**SITE PLAN: LOT 346, PHASE 4,
THE PARKE AT OCEAN PINES, SECTION 16,
THIRD TAX DISTRICT, WORCESTER COUNTY, MARYLAND**

SOULÉ & ASSOCIATES
 ENGINEERING / SURVEYING / PLANNING
 122 ARLINGTON ROAD
 ARLINGTON BUSINESS CENTER
 SALISBURY, MARYLAND 21801
 (410) 742-7797

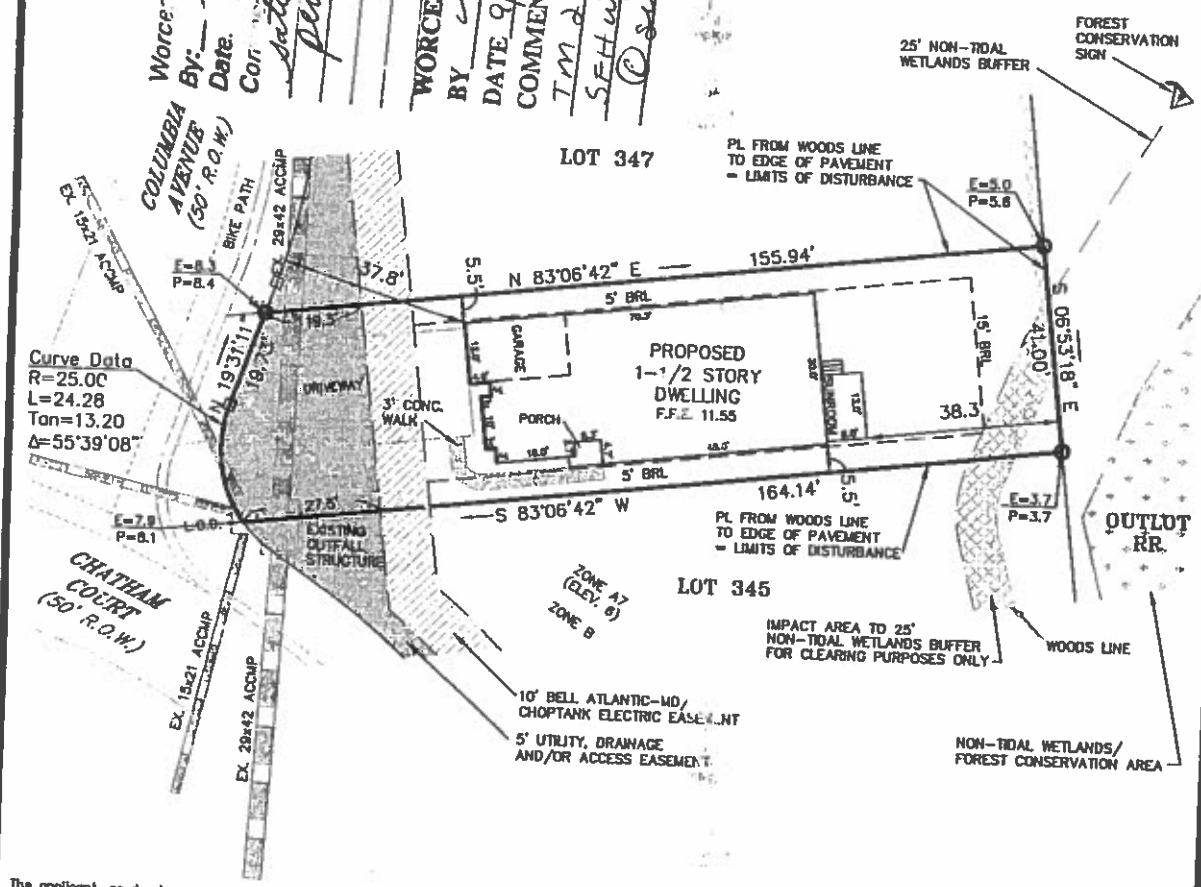
Worcester County Area Reviewer
 By: *S. Wilson*
 Date: *9-20-03*
 Comments: *100% rule satisfied by SWM plan 8/14/03*

WORCESTER CO. ZONING REVIEWER
 BY: *[Signature]*
 DATE: *9/17/03*
 COMMENTS: *BR# 84471*
IM 21 P311 L346
SEH w/ att. garage, porch
[Signature]
